Technical Service Bulletin

SUBJECT:			No:	TSB-13-00-001
VEHICLE IDENTIFICATION UPDATE -			DATE:	January, 2013
SERVICE MANUAL REVISION			MODE	L: 2013 Outlander Sport
CIRCULATE TO:	[] GENERAL MANAGER	[] PARTS MANAGER		[X] TECHNICIAN
[X] SERVICE ADVISOR	[X] SERVICE MANAGER	[] WARRANTY PROCESS	OR	[] SALES MANAGER

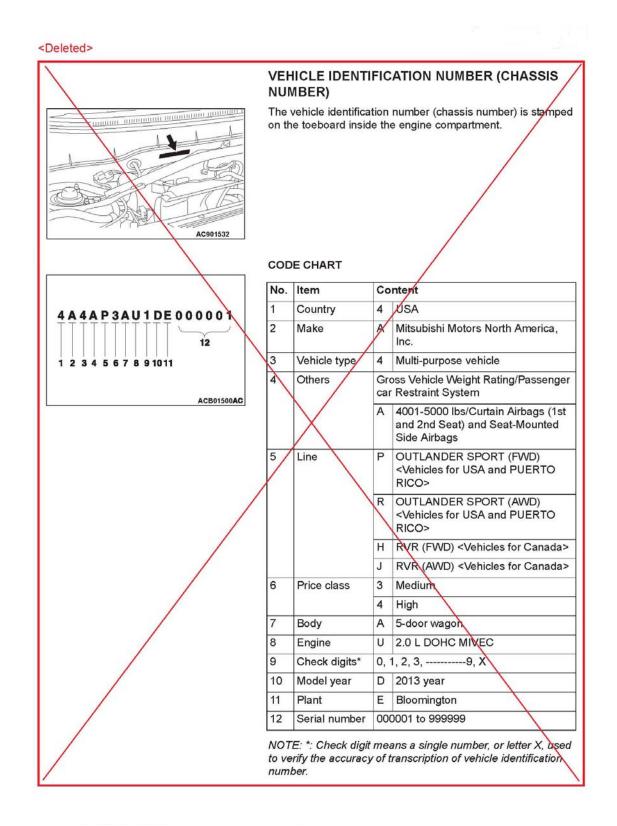
The VIN stamped on the toe board inside the engine compartment was removed and the vehicle information code plate was changed to a label for 2013 vehicles. This TSB updates the service manual with the correct information.

Please delete the VIN chassis number as shown below:

Please replace the vehicle information code plate with the provided information:
